Work Order ID 101164

Item Name: Crosstube Turning Detail

DART AEROSPACE LTD		Work Order:	101164
Description: Crosstube Assembly (205/212/412 High Fwd)		Part Number:	D212-664-141
Inspection Dwg: D212-664-141 Rev: D		Page 1 of 2

DRAWING NO. D212-664-141	TITLE XTUBE ASSY (205/212/412 HI FWD)	REV. D	DART AEROSPACE LTD ENGINEERING ORDER		D.E.O. NO. D212-664-141-D-1	SHEET NO SHEET 1 OF 2	SCALE NTS
DRAWN	CHECKED	OP	MFG. APPR.	APPROVED	NA	DE APPR	
DATE 11.04.07	DATE 11.04.11		DATE 11.04.12	DATE 11/04/12		DATE 11.04.12

D212-664-141/-141B
ASSEMBLY DETAIL

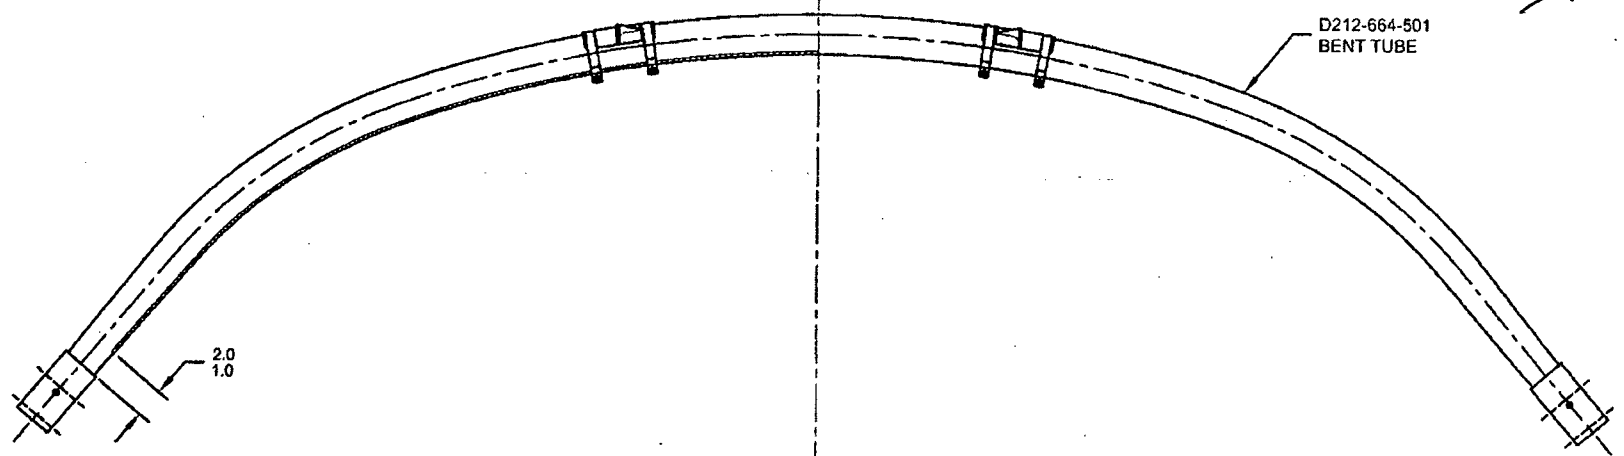
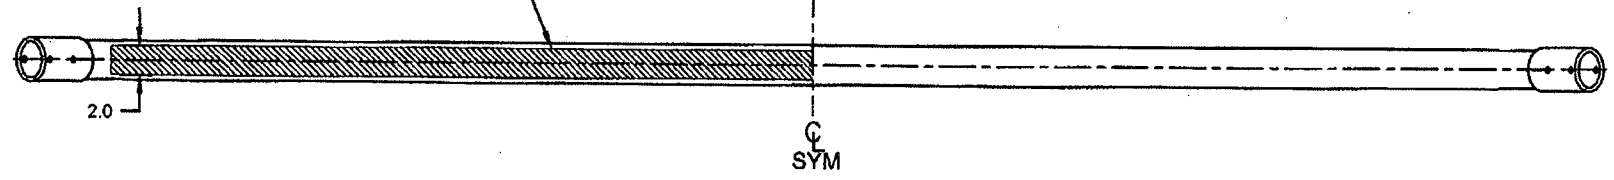
ADD AN INSPECTION WINDOW TO UNDERSIDE OF CROSSTUBE.

IS:

WAS:

MASK AREA PRIOR TO PAINTING.
REMOVE MASKING AFTER PAINT
AND APPLY CLEAR COAT
